RFI

RFI #: PB-009

Job: D21015 Spreckles Memorial Park ADA

Subject: Pre-Bid RFI #009 - (E) Concrete Walkway

PROPOSED EXTERIOR CONCRETE
WALKWAY PLAN

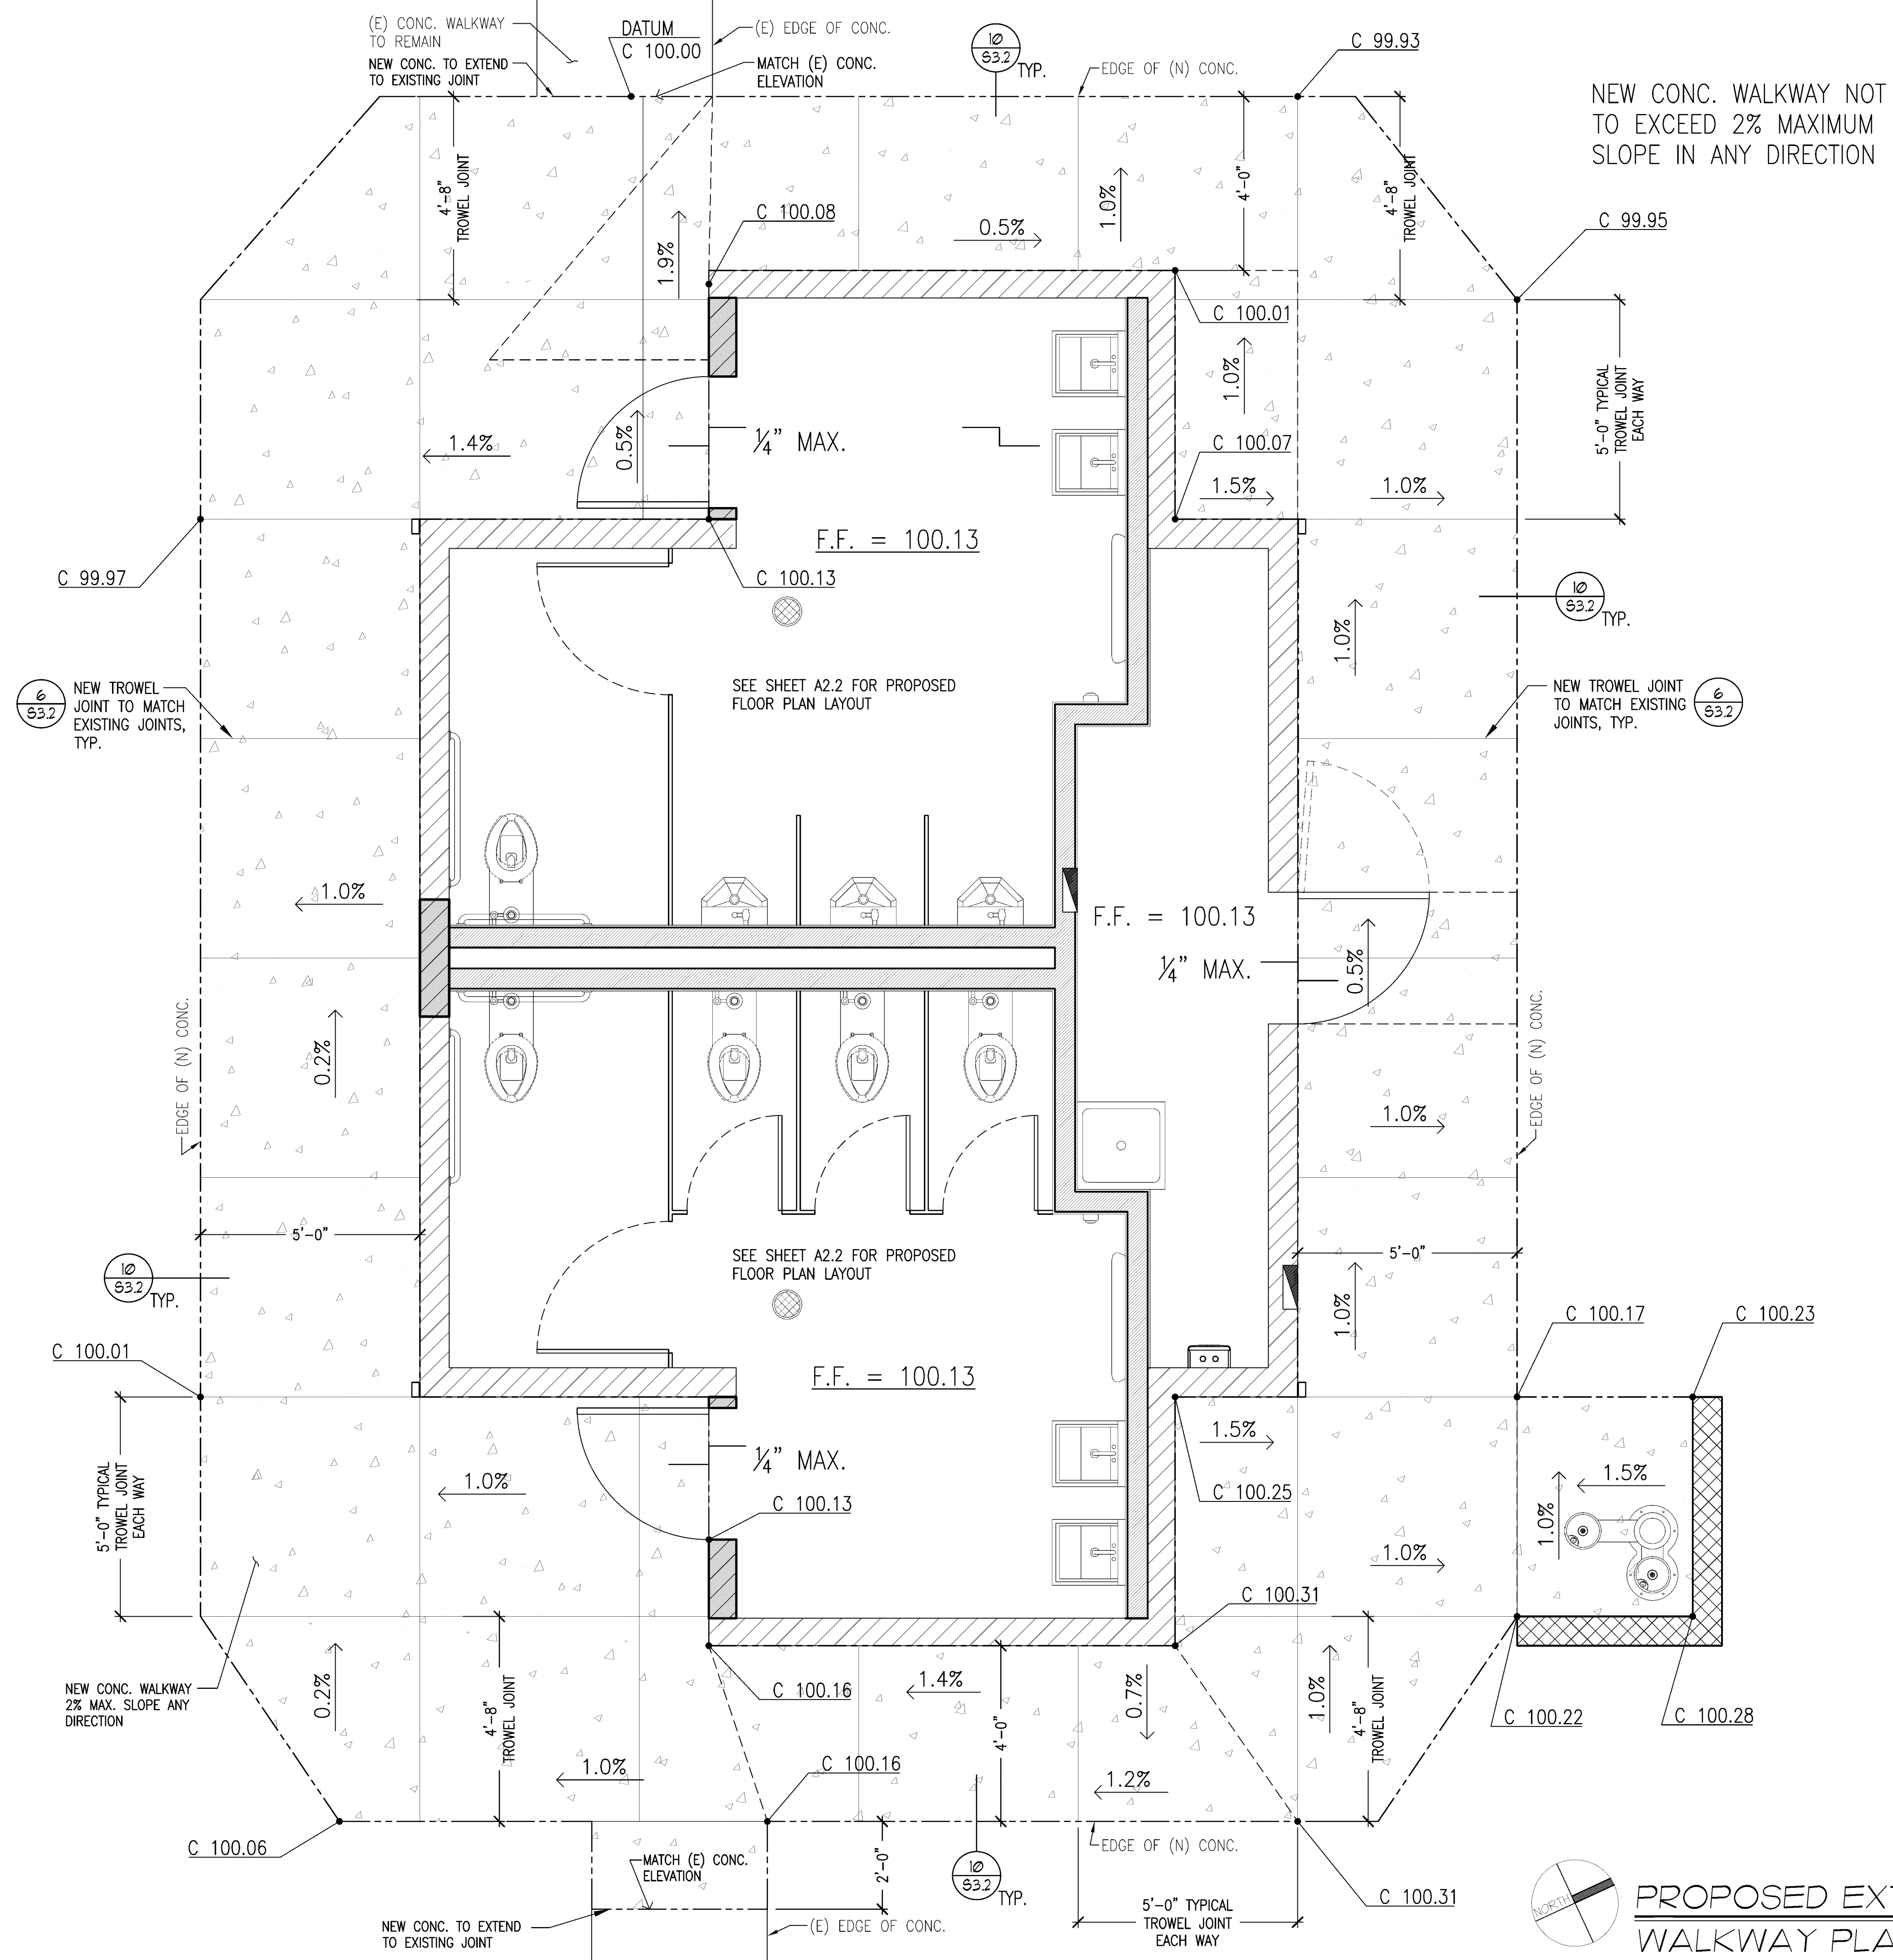
Sheet A2.1 shows the existing concrete walkway to remain, but sheet P1.1 shows a 2" waste line from the new water fountain into building. Please clarify.

Will part of the existing concrete pathway need to be demo'd and patched back?

All new walkways around building sheet A2.1
